# HISTORIC AND DESIGN REVIEW COMMISSION

August 18, 2021

**HDRC CASE NO:** 2021-381  
**ADDRESS:** 112 SOLEDAD ST  
**LEGAL DESCRIPTION:** NCB 106 BLK LOT 8A  
**ZONING:** D, H, RIO-3  
**CITY COUNCIL DIST.:** 1  
**DISTRICT:** Main/Military Plaza Historic District  
**APPLICANT:** Davis Sprinkle/Sprinkle & Co. Architects  
**OWNER:** Derek Rosson/RS Merit  
**TYPE OF WORK:** Repair and maintenance, roof top addition, rear addition, river level wall modifications, site and landscaping modifications  
**APPLICATION RECEIVED:** July 30, 2021  
**60-DAY REVIEW:** Not applicable due to City Council Emergency Orders  
**CASE MANAGER:** Edward Hall  
**REQUEST:**

**REQUEST: Rehabilitation, construction of a rooftop addition, a 3-story rear addition, river wall modifications**

WEST ELEVATION - ALONG SOLEDAD ST.  
1/16" = 1'-0"

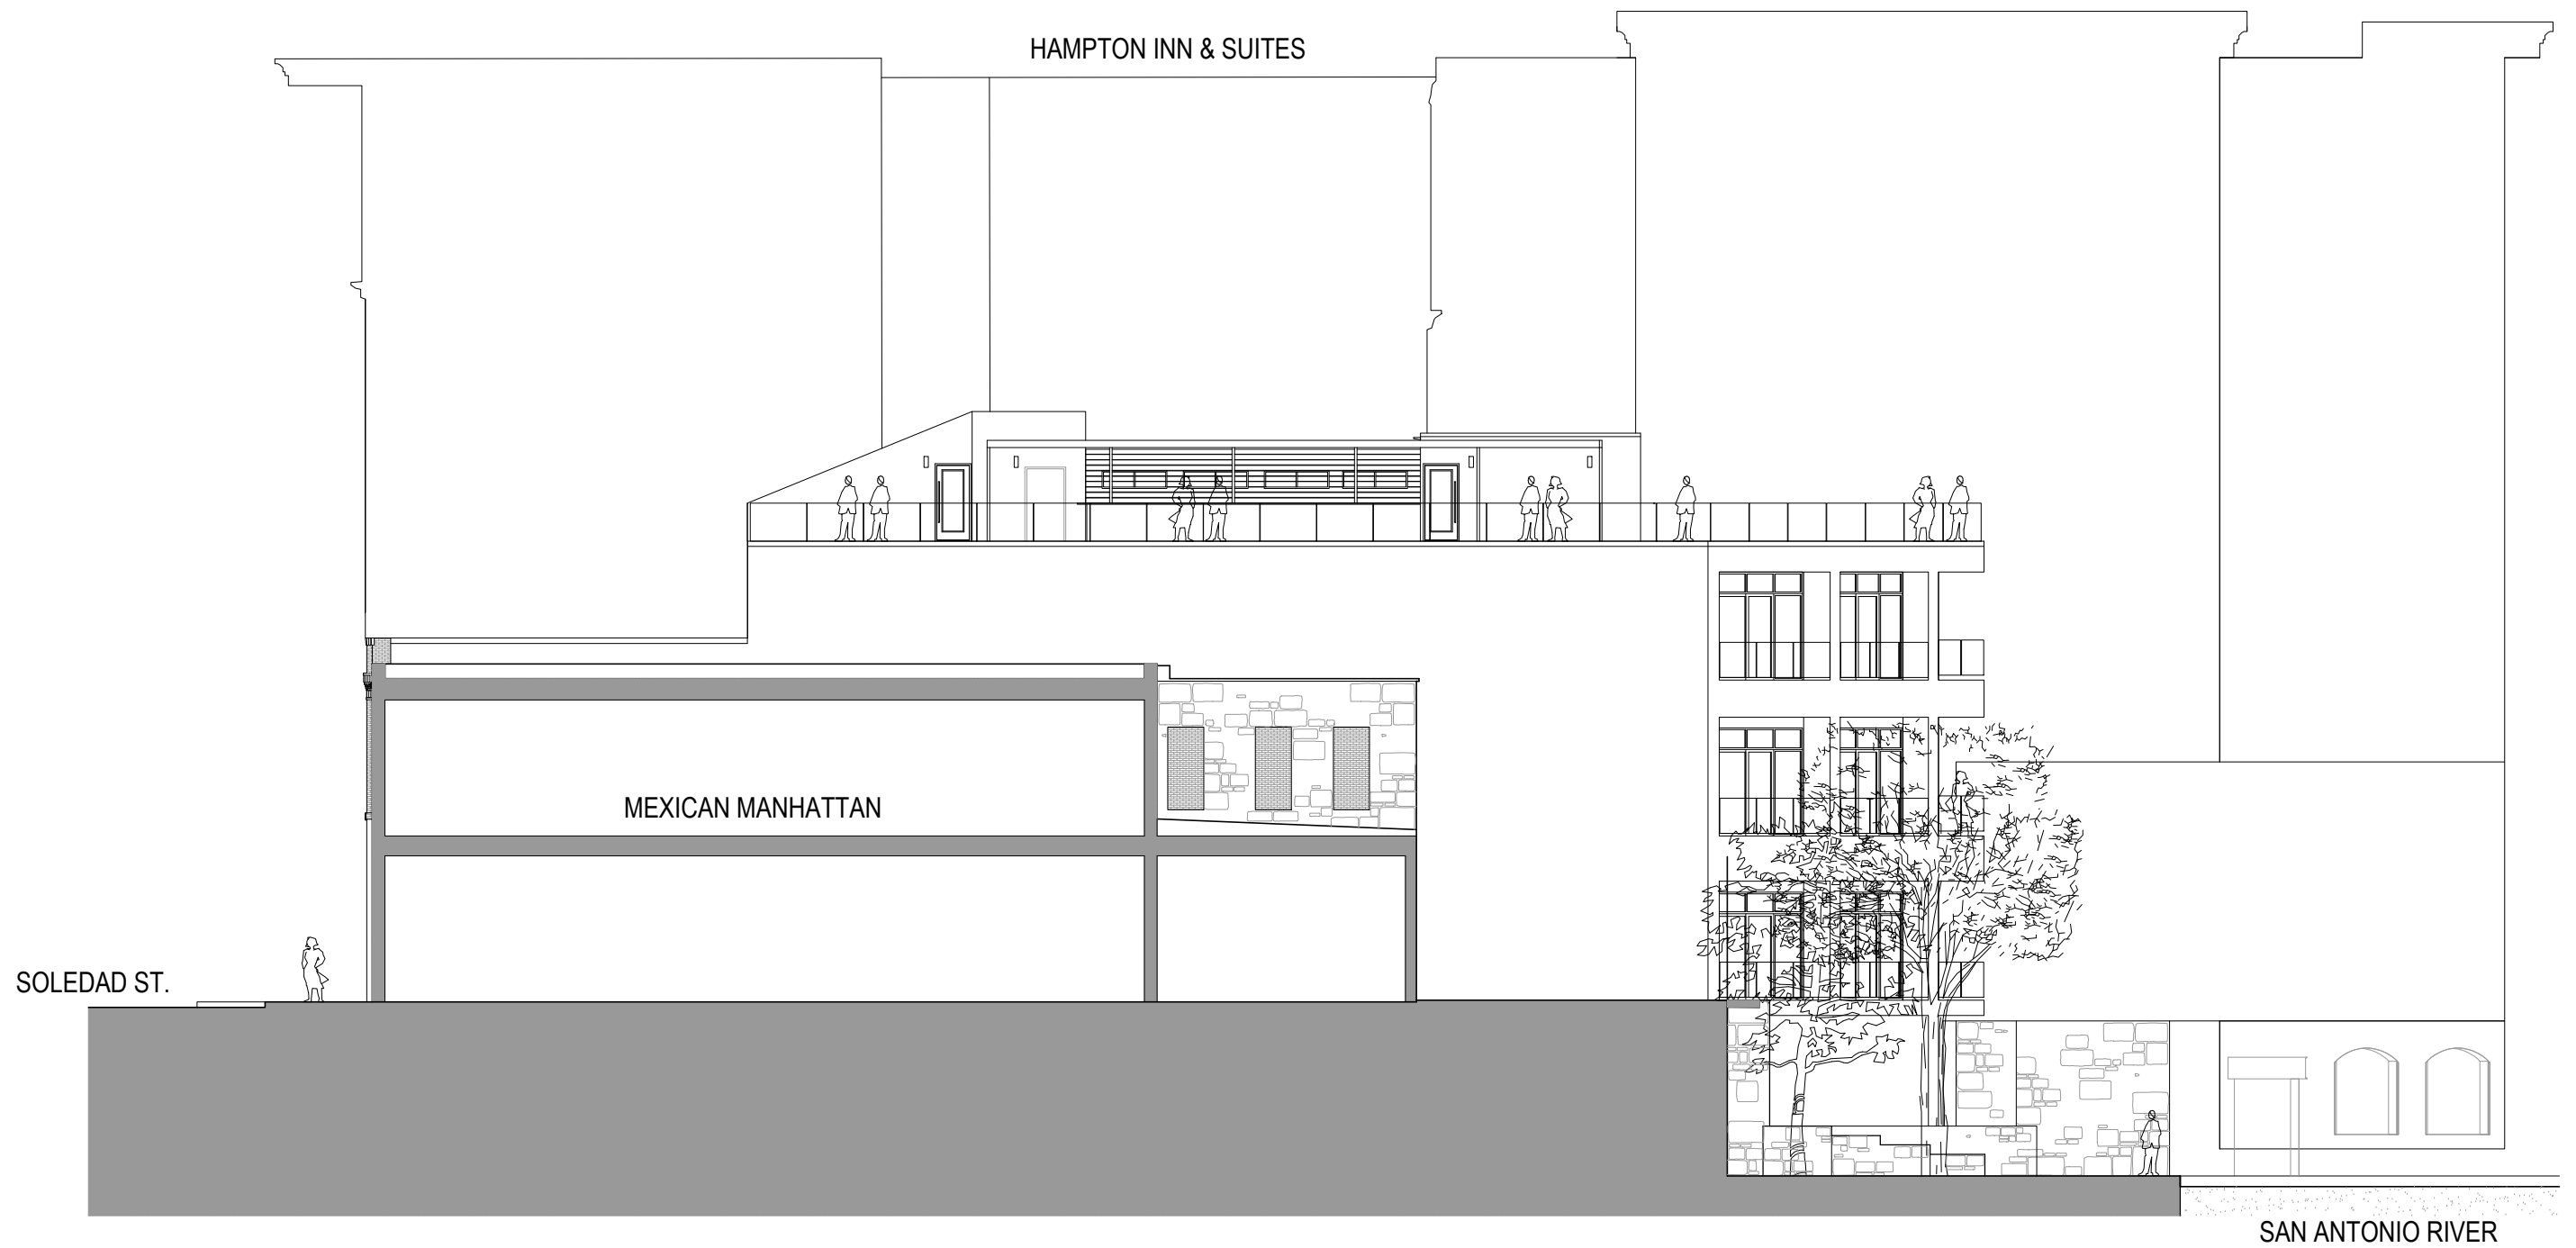
- d. **FAÇADE MODIFICATIONS** – The applicant has proposed to perform modifications to the street level of the street facing façade. The current façade features non-original materials and a non-original profile, consistent with storefront modifications from the 1950's. The applicant has proposed to remove all, non-original stucco, re-introduce transom windows, install a new street canopy, and install a new storefront system. Generally, staff finds the proposed scope of work to be appropriate and consistent with the Guidelines for Exterior Maintenance and Alterations. Staff finds that the applicant should develop all rehabilitative and reconstructive scopes of work to be architecturally consistent in form and profile with those elements found historically in the immediate vicinity, to include canopies, transom window openings and profiles, and storefront system profiles.

1. Staff recommends approval of item #1, modifications to the street level, street facing façade based on finding d with the stipulation that the applicant develop all rehabilitative and reconstructive scopes of work to be architecturally consistent in form and profile with those elements found historically in the immediate vicinity, to include canopies, transom window openings and profiles, and storefront system profiles. Additionally, staff finds that the proposed new canopy should be reduced in profile.

RIVER LEVEL

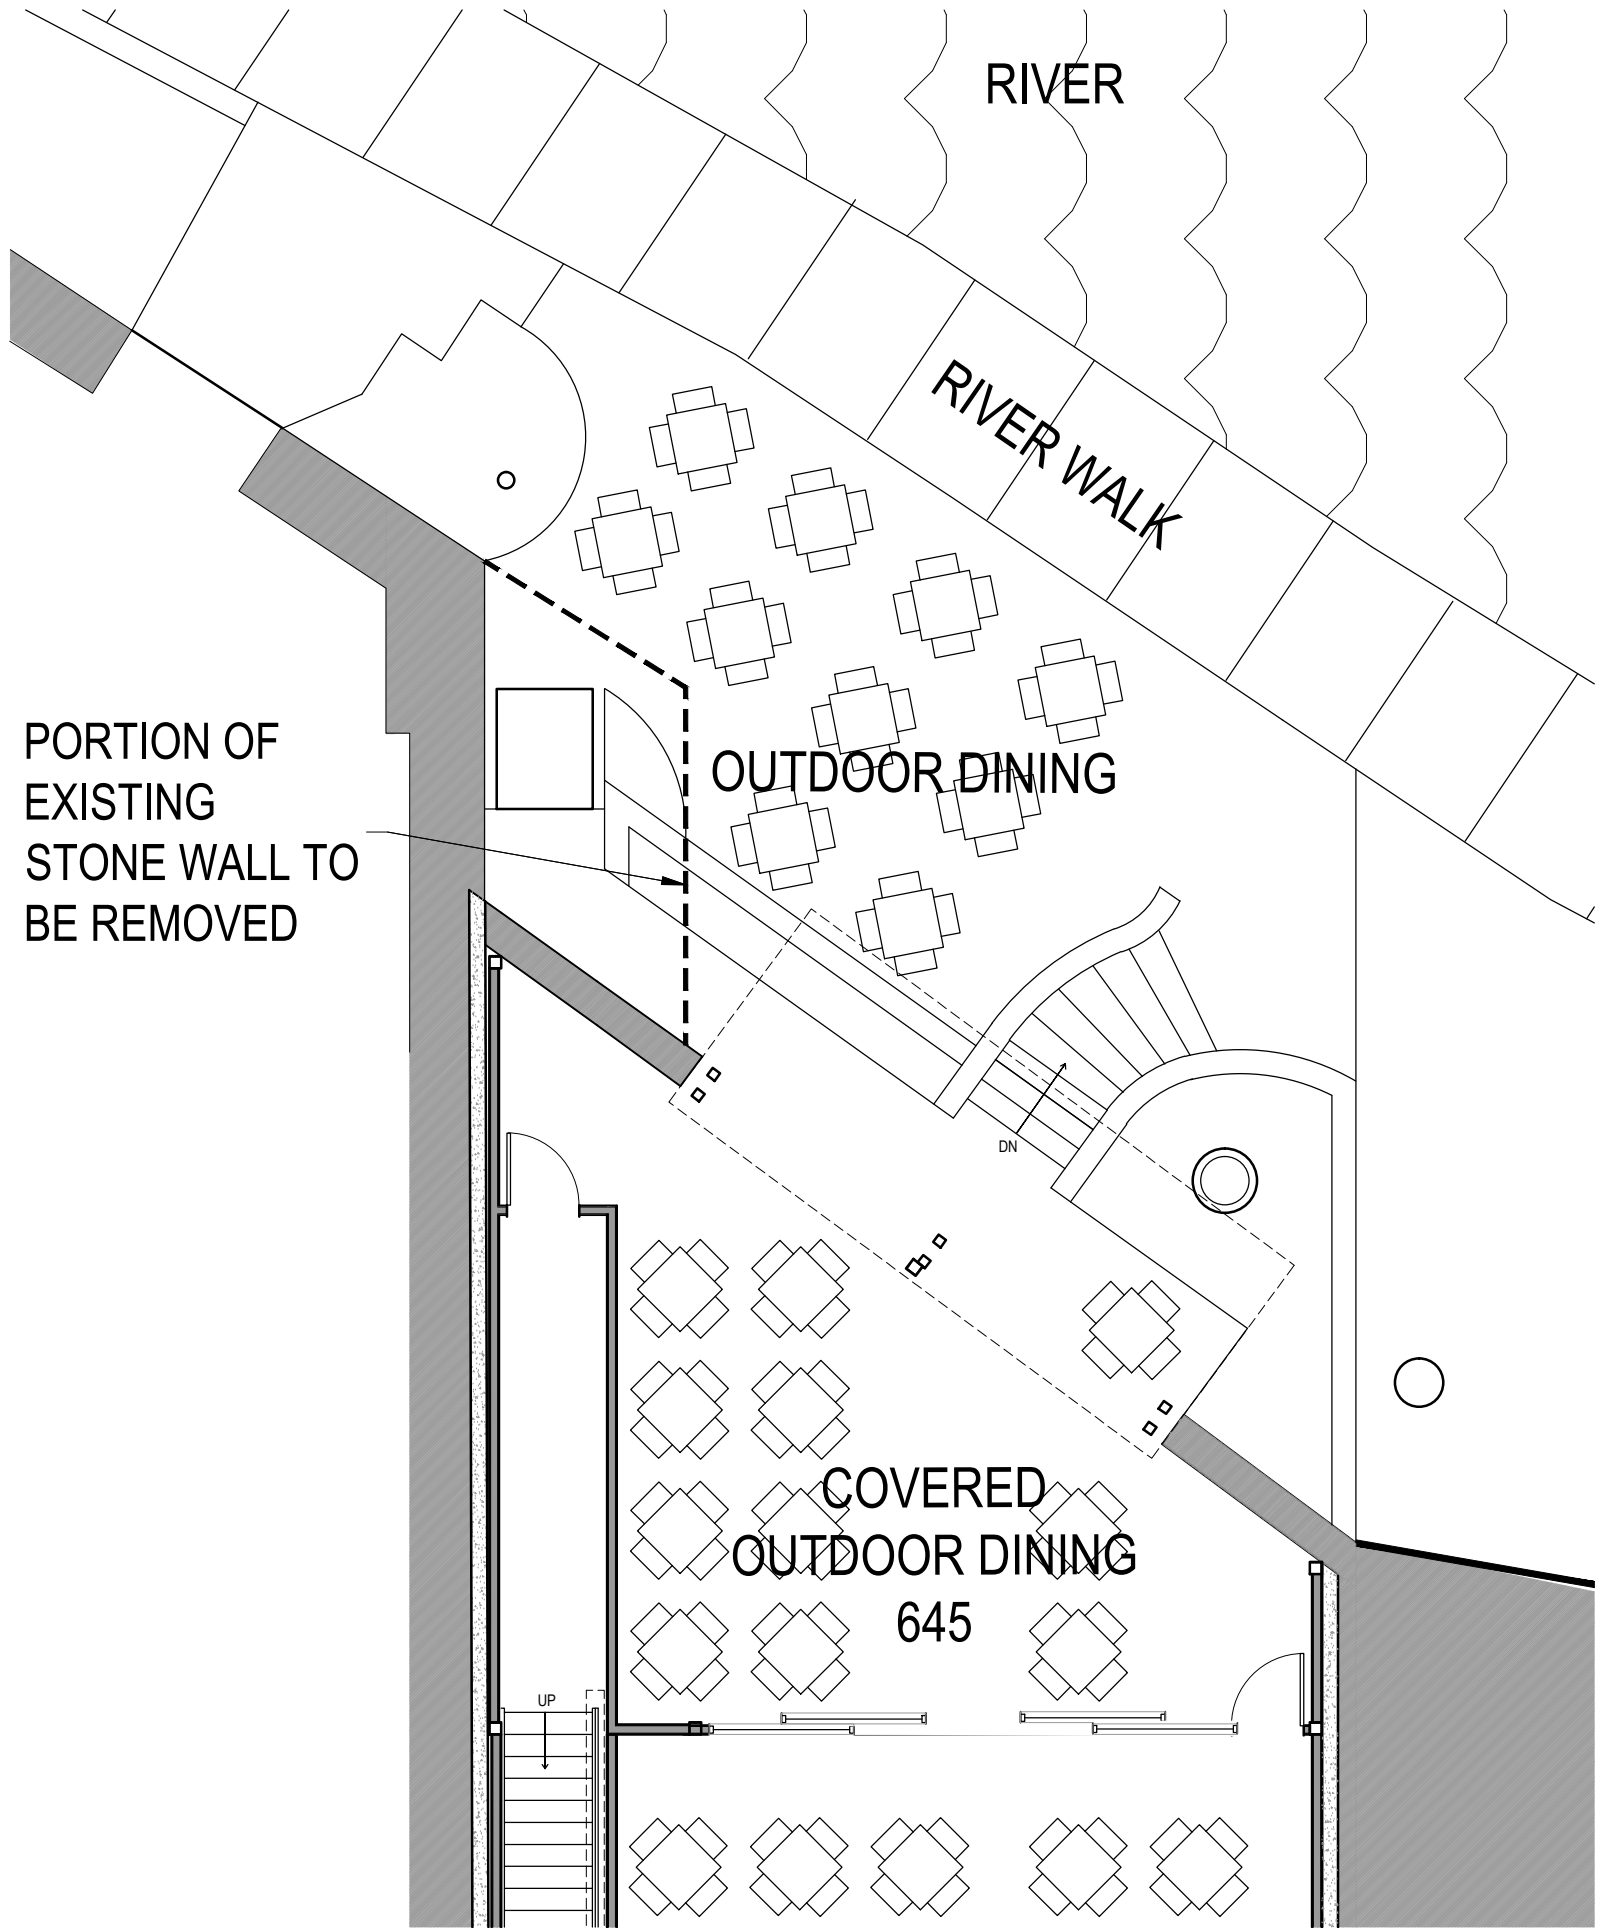
- m. RIVER LEVEL MODIFICATIONS – The applicant has proposed to modify the existing site and landscaping at the river level. The applicant has proposed an outdoor dining space as well as hardscaping where landscaping currently exists. Generally, staff finds the proposed modifications to be appropriate; however, staff finds that a detailed landscaping and river level site plan should be submitted noting paving materials and finishes and patio furniture. Additionally, staff finds that the applicant should coordinate with the Center City Development & Operations Department regarding the proposed site modifications and lease agreements.

JF: The proposed river side terrace needs more development. More planting and vegetative elements are needed.

5. Staff recommends approval of item #5, modifications to the rear level site and landscaping with the stipulation that a detailed landscaping and river level site plan should be submitted noting paving materials and finishes and patio furniture. Additionally, staff recommends that the applicant coordinate with the Center City Development & Operations Department regarding the proposed site modifications and lease agreements.
